Service Technical Information

MODEL NO. XR-H330MD
SUBJECT Sound leakage from the High-Tone speaker during the use of the headphone set

REF.No. :G - A0 - 085- E0

DATE :24. OCT. 2000

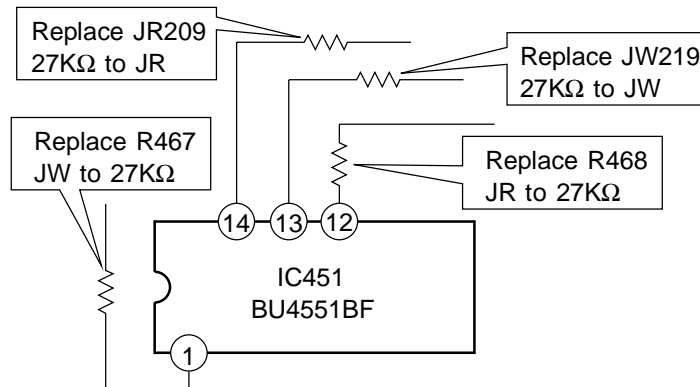
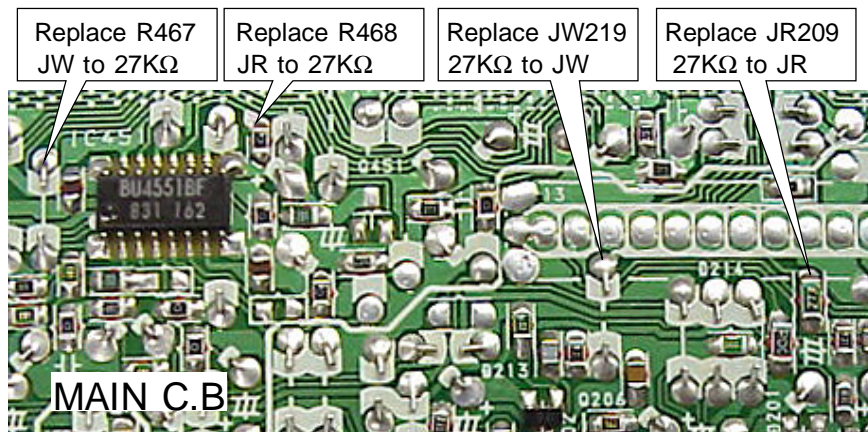
When the volume is increased with the headphone set mounted, sounds may leak from the High-Tone speaker.

Replace the required components mounted on the MAIN C.B. The procedure is as follows:

- 1) Remove the jumper wire (JW) from the R467, and instead, mount a 27KΩ resistor.
- 2) Remove the chip jumper wire (JR) from the R468, and instead, mount a 27KΩ resistor.
- 3) Remove the JR209 27KΩ resistor, and instead, connect a chip jumper wire (JR).
- 4) Remove the JW219 27KΩ resistor, and instead, connect a jumper wire (JW).

*Use either suitable lead wires or conductors as the jumper wires.
